Re: ACP-323849-25

Mixed use development that seeks the regeneration and adaptive reuse of a strategic brownfield site, as part of the Limerick City and County Council 'World Class Waterfront revitalisation and transformation project' 'Cleeves Riverside Quarter' in the townland of Farranshone More in Limerick City.

We refer to your letter of the 25th March 2026 and the further information sought under Section 175(5)(a) of the Planning and Development Act 2000 as amended. An integrated response has been prepared by the Design Team in relation to the 6 no. headings detailed in your letter and it is proposed to respond to each of the 6 no. issues in turn.

Figure 2.0 Extract of northern site boundary with landscape annotations

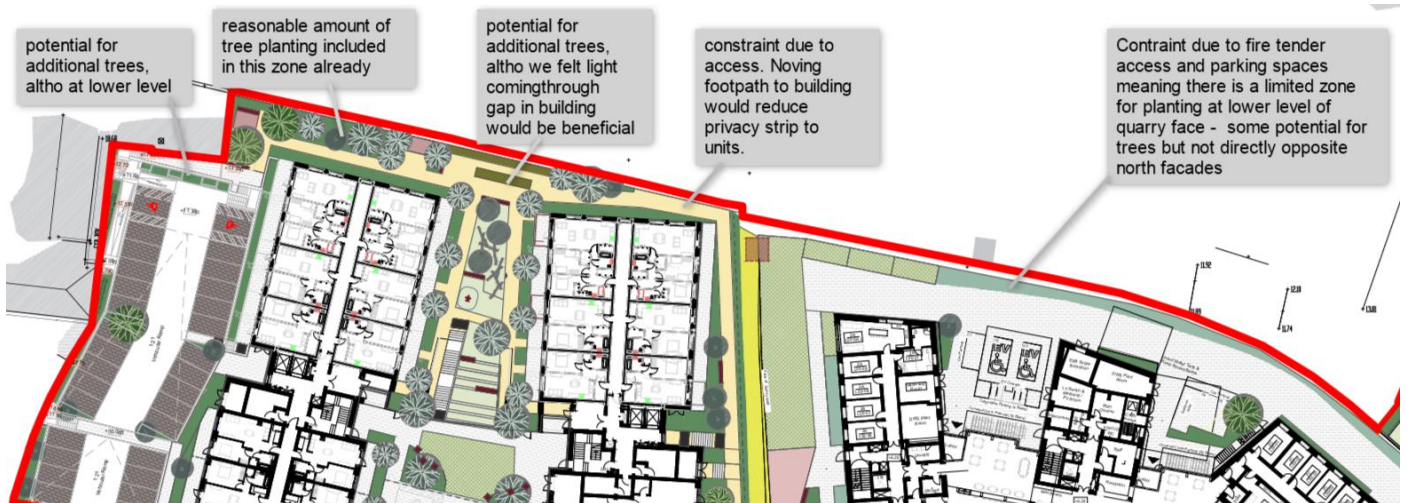
The observations received requested landscaping of trees between the existing boundary wall to the rear of Clanmaurice Avenue and to the northern boundary of the Salesians and Quarry Zones. You are required to submit a revised landscaping plan at a scale of 1 :200 indicating a variety of semi-mature trees predominately native species such as mountain ash, birch, willow, sycamore, pine, oak, hawthorn, holly, hazel, beech or alder between existing rear boundary wall of Clanmaurice Avenue and the northern boundary of the Salesians and Quarry Zones.

The northern boundary to Clanmaurice Avenue gardens had been populated with a planting buffer, though some more trees can be planted around constraints. The path around Salesians cannot be moved closer to the building because of privacy, so this limits the planting of more trees to the north of this area. The PBSA boundary has many constraints including spatial confines of the quarry face and reservoir; levels; and habitat. As a result it is difficult to add more trees in this area. However, some additional planting is proposed adjacent to the quarry face notwithstanding its limited beneficial impact on third parties because of the level change.. In total 10 no. trees are proposed to be added along the northern boundary of the Salesians and Quarry Zones.

The drawing extract in Figure 2.0 rationalises the approach to planting on the northern boundary of the site whilst Drawing CRQMP-MLA-ZZ-XX-DR-L-1000 has been updated to show additional planting along the northern edge
